SUBJECT: Requests relief from ASME Section XI requirements re welds found to be partially inaccessible during first 90% of preservice insp baseline. Remaining 10% of baseline exams should be completed before June 1982.

Subject: NUCLEAR PROJECT 2
ASME SECTION XI INSERVICE INSPECTION
REQUEST FOR RELIEF NO. PSI-2-001

REQUEST FOR RELIEF NO. PSI-2-001

DWG NO. RPV-101

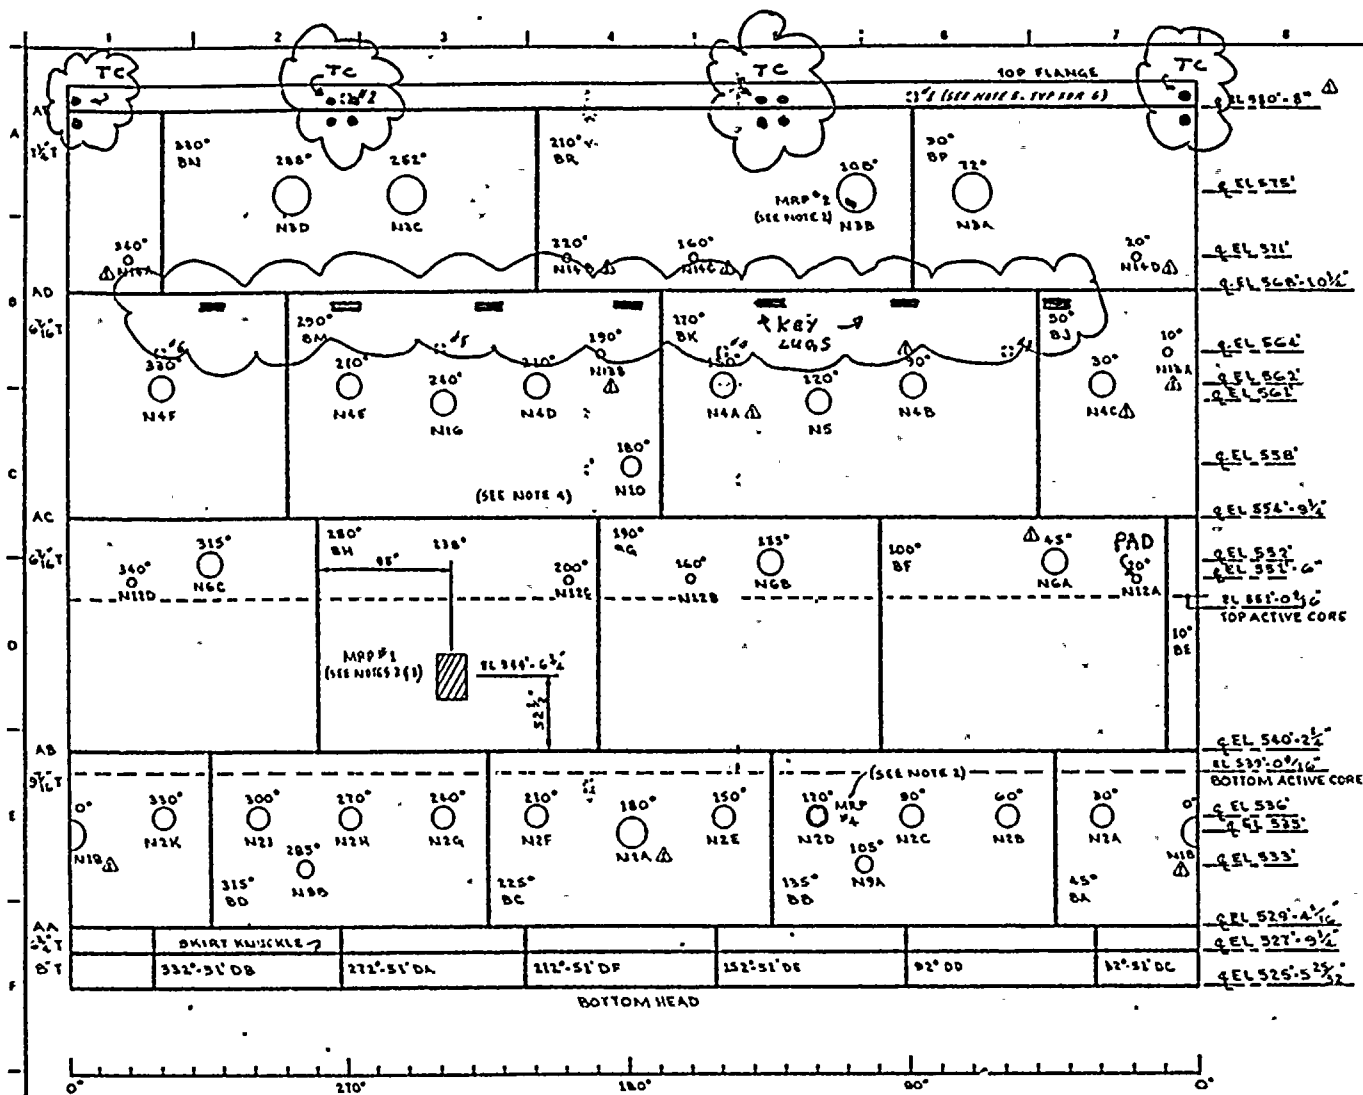
ISO. NO.	WELD NUMBER	DATA SHEET	DESCRIPTION	SECTION III EXAM	REMARKS
RPV-101	AE	1210-1, 1A, 2, 2A, 3	Vessel to Flange	MT, UT, RT	Thermocouples at 135°, 270°, and 360°
RPV-101	AD	1210-13, 14, 15, 5, 9, 7, 8, 16	#3-#4 SC-CRC WD	MT, UT, RT	7. 2-foot long key lugs obstruct weld @ 45° intervals
RPV-101	BJ	1210-5, 7, 8	#3 SC VRT WD @ 50°	MT, UT, RT	Key lug at weld AD intersection
RPV-101	BK	1210-6, 46, 16, 21	#3 SC VRT WD @ 170°	MT, UT, RT	Key lug at weld AD intersection
RPV-102	DA	1210-35, 38, 42	BTM HD MRD @ 272	MT, UT, RT	Thermocouples at weld AA intersection Note: The above UT exams were done by NES before the vessel was installed.
RPV-102	DG	RPU-085, 075, 094, 126	BOT HD DOL @ 270°	MT, UT, RT	See Note 1
RPV-102	DR	RPU-086, 076, 095, 127	BOT HD DOL @ 90°	MT, UT, RT	See Note 1
RPV-102	DA	RPU-088, 116, 078, 110, 104, 106	BOT HD MRD @ 272°	MT, UT, RT	See Note 2
RPV-102	DB	RPU-089, 117, 079, 111, 099, 107	BOT HD MRD @ 332	MT, UT, RT	See Note 2

Note 1: Only 12" to 23" on each end of the weld, starting from the intersection of weld AJ, can be examined due to CRD penetrations and housings.

DWG NO. RPV-102.

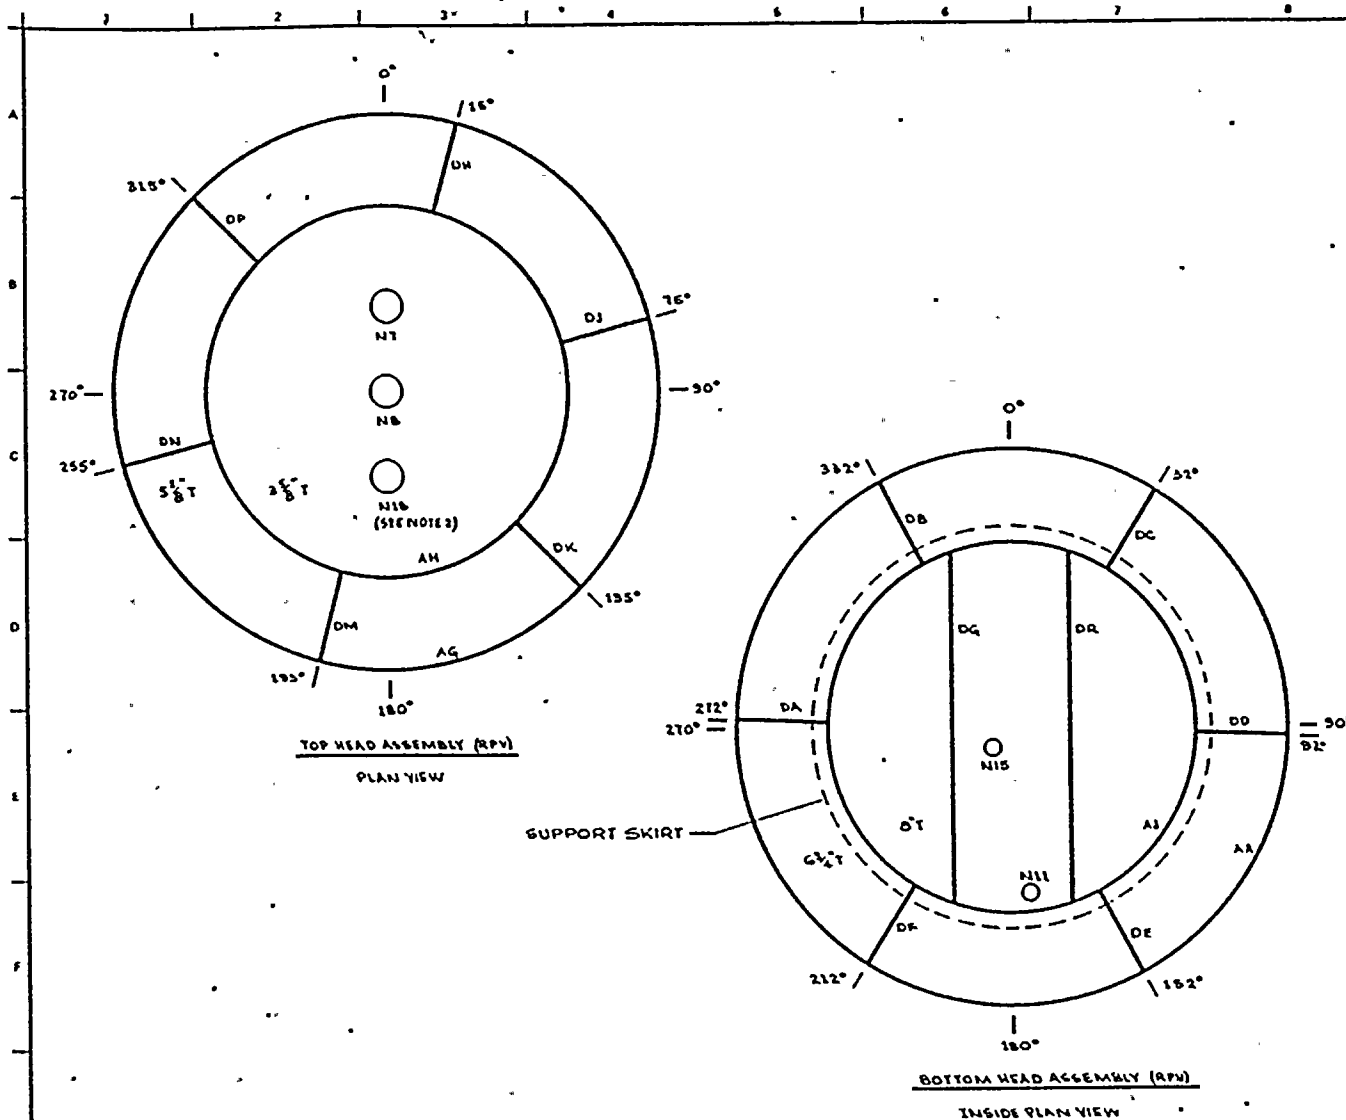
Note 2: Only 21" starting from the intersection of weld AA and 14" starting from the intersection of weld AJ can be examined due to vessel support skirt. (Approximately one foot is not being examined on each weld.)

20 RHR (1) A-4

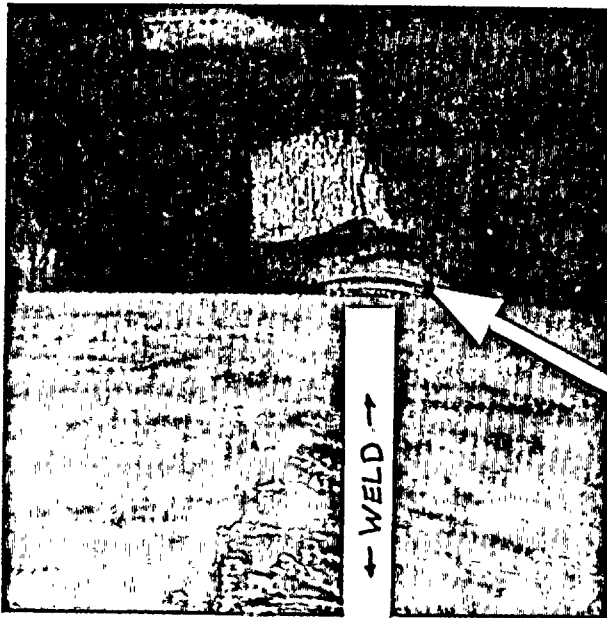
ISO. NO.	WELD NUMBER	DATA SHEET NO.	SEC. XI EXAM	DESCRIPTION	SECTION III EXAM	REMARKS
RHR-201	20 RHR(1) A-4	RHP-190	PT	Pipe to Reducer	RT	No surface exam 330°-30° due to permanent obstruction (6" not examined). Alternate exam UT from 1 side.
RHR-207	18 RHR(1) B-7/ 6 RHR(7)-2	RHP-154	PT	Branch Connector	RT	1½" around 0° not examined due to permanent (welded hanger) interference.
RHR-207	20 RHR(1) B-4	RHP-201	PT	Pipe to Elbow	RT	No surface exam 330°-0°-30° due to permanent obstruction (6" not examined). Alternate exam UT from 1 side.
RHR-207	18 RHR(1) B-42	RHP-201	PT	Pipe to Elbow	RT	No exam 4" around 180° obstructed by permanent hanger.
RFW-101	18 RFW(1) A-4	FWP-046	PT	Pipe to Reducer	RT/PT	2½" around 0° not examined-welded "N" stamp.
RHR-106	12 RHR(1) B-11LDO	RHU-075	UT	Elbow Seam	RT/PT	No exam 4" to 5½" due to branch connection (1½" not examined).
RRC-101	24 RRC(2) A-8LDI	RRU-101	UT	Elbow Seam	RT/PT	No exam 18" to 19" due to instrument line interference (1" not examined).

These two welds will be examined by UT in the areas where PT was not possible.

24RRC(2)A-8LD0

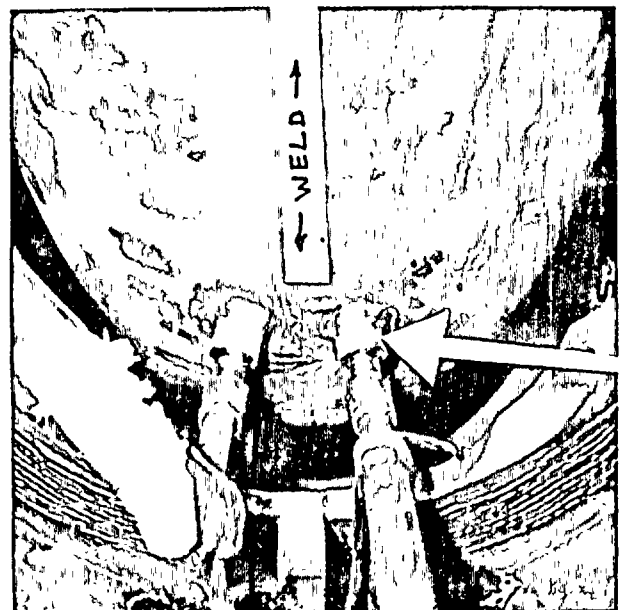
RRC-101	24 RRC(2) A-8LDO	RRU-101	UT	Elbow Seam	RT/PT	No exam 38" to 40" due to branch connection (2" not examined).
RRC-102	24 RRC(1) B-6LDI	RRU-112	UT	Tee Seam	RT/PT	No exam 17" to 18" due to fitting (1" not examined).
